Access Compliance Report

Public Rights-of-Way

(Curb Ramps)

Intersection ID: 31225	Main Street: CLACKWYCK_LN	Cross Street: GRANTHAM_LN	Location: E
ADA ID: 287E59C503E5	Ramp Type: Perp	Initial Pass/Fail: Fail	Overall Compliance: No
		Severity Score: 50

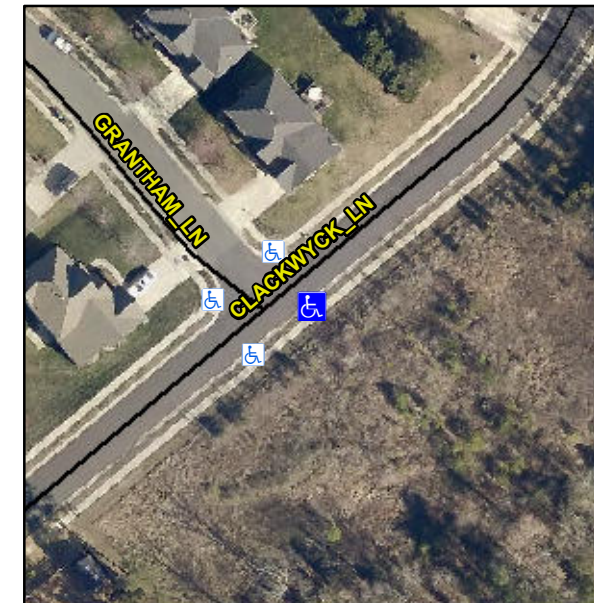
Not Found, R304.2.2, R304.5.3

Compliance	Description	Data	Compliance	Description	Data
N/A	Ramp Length (in)	45.0	No	Ramp Slope (%)	13.9
Yes	Ramp Width (in)	48.0	No	Ramp XSlope (%)	10.3
N/A	Flare Type LT	N/A	N/A	Flare Type RT	N/A
N/A	Flare Slope LT (%)	N/A	N/A	Flare Slope RT (%)	N/A
N/A	Flare Traversable LT?	N/A	N/A	Flare Traversable RT?	N/A
N/A	Landing Length (in)	N/A	N/A	DWS Provided?	N/A
N/A	Landing Width (in)	N/A	N/A	DWS Contrast?	N/A
N/A	Landing Slope (%)	N/A	N/A	DWS Length (in)	N/A
N/A	Landing X Slope (%)	N/A	N/A	DWS Full Width?	N/A
N/A	Landing Curb? (Y/N)	N/A	N/A	DWS Offset (in)	N/A
N/A	Shared Landing?	N/A			
N/A	Gutter Ponding?	N/A	N/A	Gutter Slope (%)	N/A
N/A	Gutter Lip Ht (in)	N/A	N/A	Gutter X Slope (%)	N/A
N/A	Painted X Walk1?	No	N/A	Painted X Walk2?	N/A
	X Walk 1 Direction	To NW		X Walk 2 Direction	N/A
N/A	X Walk 1 Width (in)	N/A	N/A	X Walk 2 Width (in)	N/A
	X Walk 1 Slope (%)	4.7		X Walk 2 Slope (%)	N/A
	X Walk 1 X Slope (%)	10.0		X Walk 2 X Slope (%)	N/A

Remove & Replace Entire Ramp.
